EUROMOT POSITION

23 September 2013

DRAFT D1 Large Combustion Plants BREF – BAT AELs for HFO-fired Engines

Figure 6.9 HFO-fired engines – NO_x emission concentrations, yearly averages; 5th and 95th percentiles of short-term values are represented as span bars

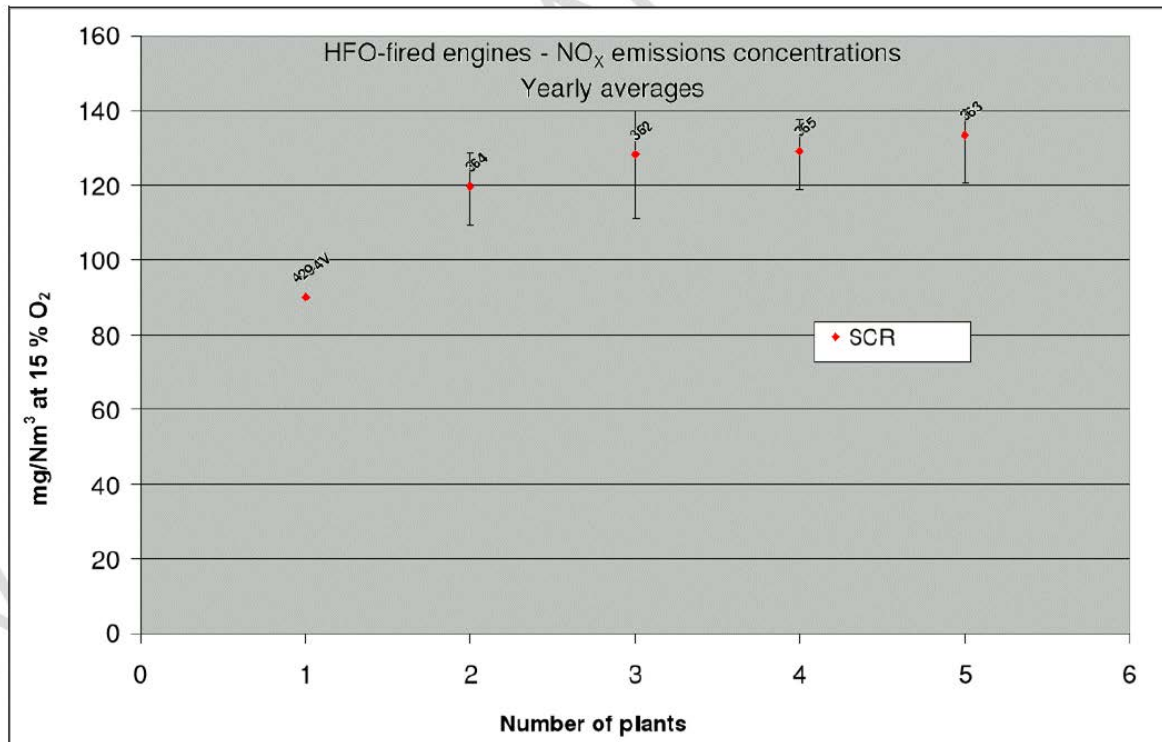
The NO_x emissions depicted in figure 6.9 (below) are only achievable when using an efficient SCR in combination with a sufficient reagent consumption (the NO_x reduction is dependent on the injected reagent amount). The reagent needed is typically a 25 wt-% NH₃ or 40 wt-% urea (urea to be of technical grade) water solution, reagent is expensive.

In the text above figure 6.9 (of BREF D1) is stated that the average NH₃ slip yearly average range was below 1 mg/Nm³ (15 % O₂), which seems to be based on the Maltese plant . This is a very low figure, to be remembered is : NH₃ measurement are difficult and a single small cold spot may absorb all NH₃ and lead to too low NH₃ results. Actual NH₃ level depends on tuning of SCR at the moment of measurement, **so the results have no value if they are not paired with the actual NO_x reduction at the moment**. NH₃ performance depends greatly on catalyst setup and performance achievable with one setup may not be possible with another. In a well tuned SCR equipped with a fresh oxidation catalyst and new fresh SCR elements this kind of very low NH₃ slip could be measured but in HFO fired plants oxidation catalysts are not recommended (will get poisoned) and with time (wear and tear) ammonia slip will increase from this level. SCR suppliers usually do not guarantee NH₃ levels less than < 10 mg/Nm³ (15 % O₂) ! A low stipulated ammonia slip limit will also result in more frequent costly SCR layer changes in a plant.

In the Greece field measurement data **following is mentioned** in the emission sheets “*BAT candidates 1) No secondary measures for Nox reduction for engines located in small isolated systems. Such measures are not technically feasible or economically viable”, primary measures are used thus NO_x emissions are as a consequence higher than in a plant equipped with SCR. This has however been neglected when setting the NO_x BAT levels in the BREF D1 !*

Note in table 6.5 of section 6.2.4 of BREF D1 a NO_x span based on obtained field data from HFO fired stationary RICE plants is give of 100 . 2500 mg/Nm³ (15 % O₂). Both plants applying only primary NO_x abatement methods (high range values) **or** SCR seem to be included in this span. **This shows that for plants for which SCR is not feasible (see above texts) higher BAT AELs are needed than proposed!**

Figure 6.10 HFO-fired engines – SO_x emission concentrations, yearly averages; 5th and 95th percentiles of short-term values are represented as span bars

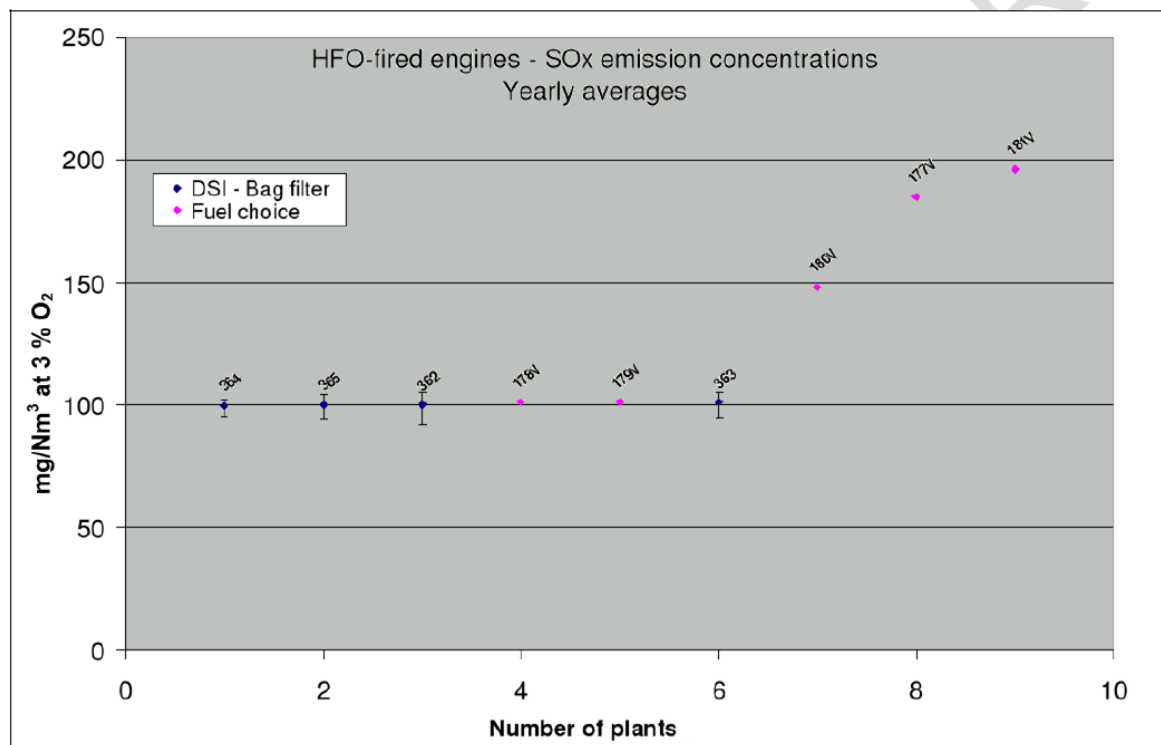
In the Maltese plant a HFO with a low sulphur content of 0.694 wt-% is used. Thus the unabated SO₂ emission should be about 400 mg/Nm³ (15 % O₂) . Below figure (6.10 of section 6.3.3.3 of BREF D1) y-axis has a reference point of 3 % O₂ which should be changed to 15 % O₂ in order to be consistent with the obtained field measurement data ! In order to achieve the 100 - 110 mg/Nm³ (15 % O₂) SO₂ level an about 75 % reduction is needed in the Maltese stationary RICE plant burning a low sulphur HFO containing 0.694 wt-% S. For a HFO containing 3 wt-% S an about 94 % SO₂ reduction should be needed which should be possible for a dry FGD only with a high reagent overstoichiometry (see Annex 3). To be remembered is that with this type of FGD the reagent is to be sent to a treatment plant (see above). **Thus for many locations this kind of FGD technology is not viable if the existing infrastructure is not good enough and full heat recovery exhaust boilers are installed in the plant (for needed flue gas cooling, see above).** In existing plants the extra needed space of the FGD unit might also be a big obstacle. With all FGD types the end product should be disposed or recycled in an environmentally acceptable way, as earlier stated Na₂SO₄ main by-product composition of the NaHCO₃ FGD needs special treatment which is not possible in all locations around the world.

Note in table 6.5 of section 6.2.4 of BREF D1 a SO_x (SO₂ ?) span based on obtained field data from HFO fired stationary RICE plants is give of 100 . 560 mg/Nm³ (15 % O₂). Both plants applying only primary SO₂ (such as choice of low sulphur S HFO) abatement methods (high span values) **or** FGD seem to be included in this span. **This shows that for plants for which FGD is not feasible (see above texts) alternative higher BAT AELs are needed than proposed !**

Question: Has SO_x or SO₂ reported ?

EUROMOT Response: We have studied the obtained field emission data (from the HFO fired stationary RICE plants) gathering sheets and **we conclude that reported emissions are probable only SO₂ and not SO_x as SO₂. → Only SO₂ component shall be regulated, NOT SO_x ! For more information see document /10/.**

Figure 6.11 HFO-fired engines – dust emission concentrations, yearly averages; 5th and 95th percentiles of short-term values are represented as span bars

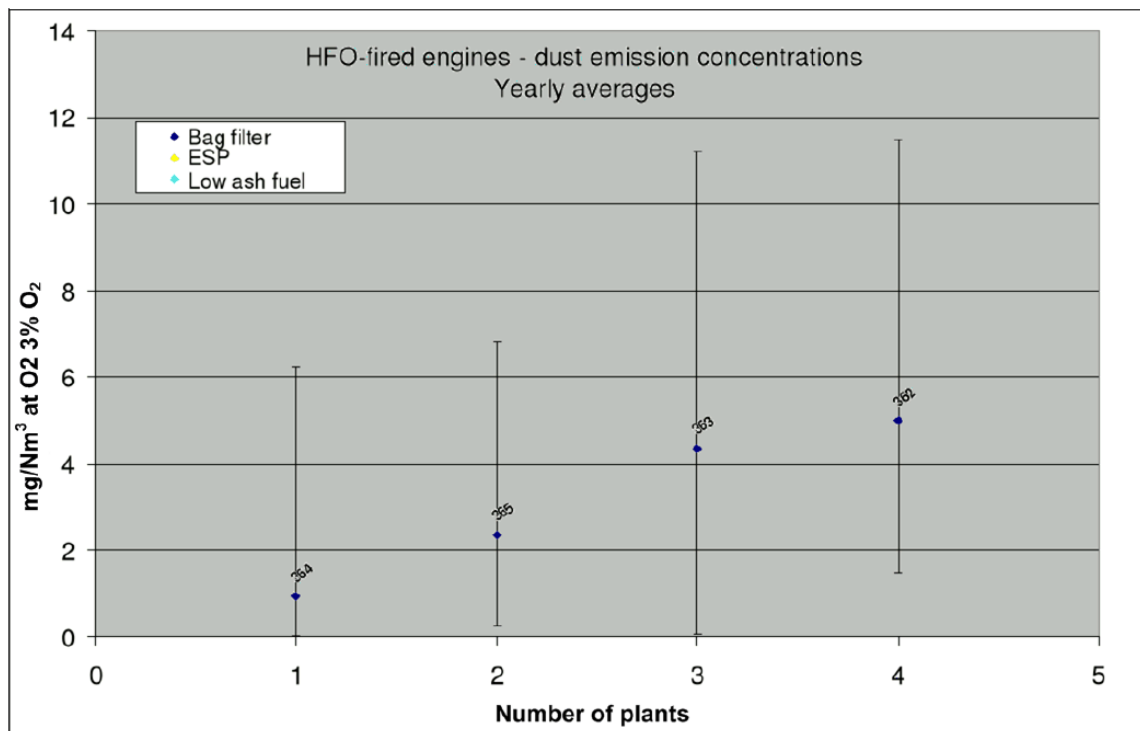
In the Maltese plant (“plants” 362 – 365) a low ash 0.024 wt-% and sulphur 0.694 wt-% HFO is used resulting in particulate emissions in estimated range of < 50 mg/Nm³ (15 % O₂) out of the engine. In below picture (6.11 of BREF D1) the reference point on the y-axis shall be 15 vol-% O₂ in order to be in line with obtained field measurement data. The particulate measurement method should also be stated (we assume EN 13284-1 measurement method or other principally similar method). **As has already been stated above performance of secondary abatement techniques usually degrade with time due to wear and tear of the filter and thus it is highly likely the proposed extremely low BAT AELs might be only achievable with new fresh filter bags. Thus proposed BAT dust limits in table 10.22 of BREF D1 based on Maltese plant emission data have to be modified.** To note also is the maximum temperature issue for the bag filter material and thus in many RICE plants this technique is not applicable. This is especially the case for peaking plants and seasonal now and then operated RICE plants. In existing plants the extra needed space of the bag filter unit might be a big obstacle. !.

Note in table 6.5 of section 6.2.4 of BREF D1 a dust span based on obtained field data from HFO fired stationary RICE plants is given of 1 ... 200 mg/Nm³ (15 % O₂). Plants applying only primary dust (such as choice of low sulphur S/ash HFO) abatement methods (high span values) **or** the bag filter FGD seem to be included in this span. **This shows that for plants for which the bag filter FGD or other secondary abatement technique such as ESP is not feasible (see above text), higher than proposed BAT AELs are needed !**

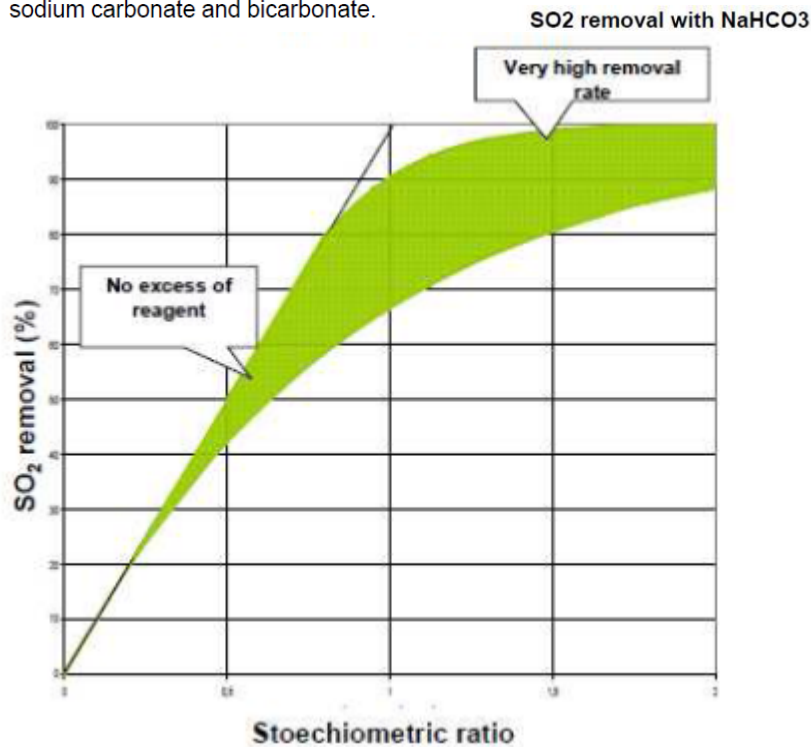
Only in table 6.5 (section 6.2.4) TOC data for stationary HFO fired RICE plants (as 15 – 75 mg/Nm³ (15 % O₂)) are given in chapter 6 of BREF D1. Nevertheless, in table 10.20 BAT associated emission level of TOC are set lower i.e. 10 – 40 mg/Nm³ (15 % O₂). To note is **that in the referred reference plant of table 10.20 (Maltese one) NO TOC emission measurements were done !** When checking the obtained field measurement data from UK, Greece and Portugal one can see that TOC was measured only in some Portuguese stationary RICE plants.

“Cherry picking” seems to have occurred. It is not technically sound to select best emission data from different plants and combine as now done. Furthermore, Euromot sent an e-mail to EIPPCB /7/ and pointed amongst all out that a check of most of the Portuguese TOC measurement results are too low and need a check. E.g. the engine manufacturer of reference 427-8 has also informed that TOC emissions from a new well maintained engine should be higher than reported value - Note that measured TOC value in reference 427-7 starts to be in the correct range for a new well maintained big engine (same engine type in same plant and difference between references 427-7 and 427-8 is 400 %. Measurements based on only a few samples → **big variation errors** .. measurements seem to be difficult to conduct in field conditions !).

BIG changes of the TOC BAT range text is needed. TOC emission is dependent on the engine condition and load and might therefore vary a lot from time to time. The challenge is that when operating on HFO an oxidation catalyst cannot be used due to poisoning effect of the impurities in the fuel. **Then best cost effective way to reduce TOC is to perform scheduled maintenance of the engine as also the current EU LCP BREF 2006 proposes in chapter 6.5.5.5. and no limit value is stipulated*.**
